**DCM600/1000**

DRAWN BY:	C. McEUEEN	DATE:	23MAY97
APPROVED:		DATE:	
PCB NO:	30-01200	REV:	C
ASSY. NO:	80-01000	REV:	H
REVISED BY:	C. McEUEEN	DATE:	14OCT98

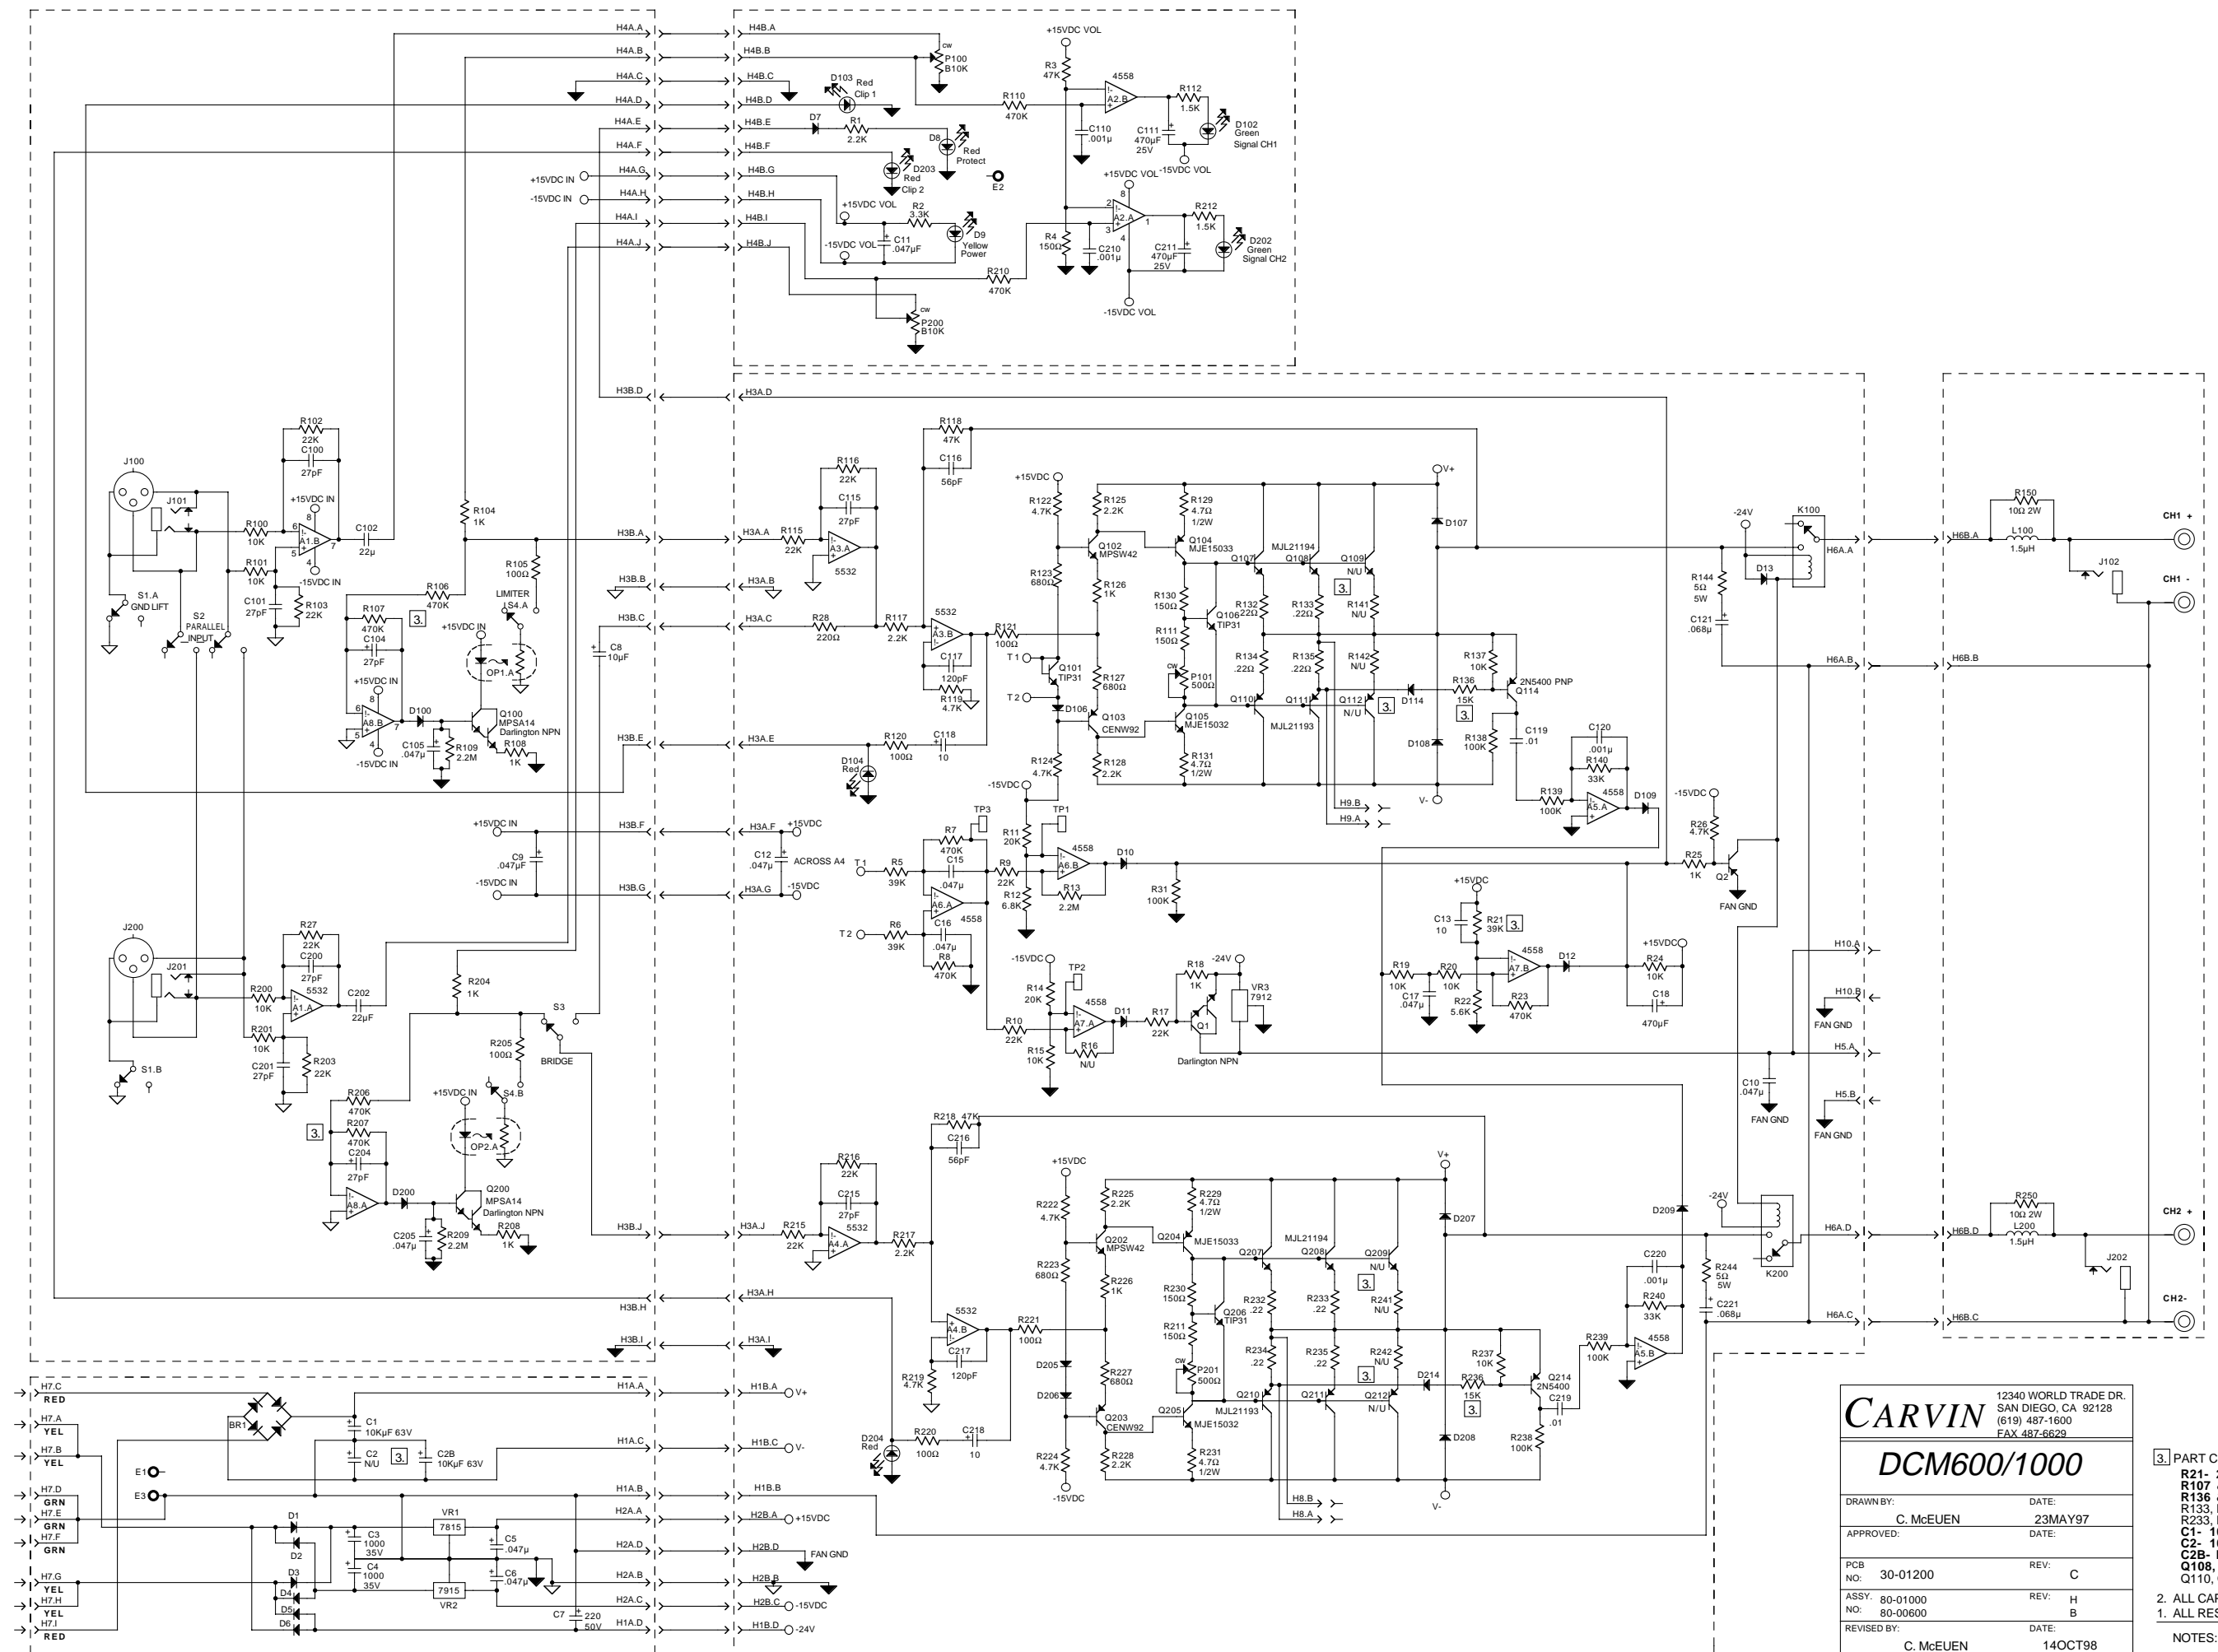
Changes from:  
 Assembly 80-00600 Rev (B):  
 1. R107, R207 TO 470K.  
 2. PCB AND 80-00100 UNCHANGED.
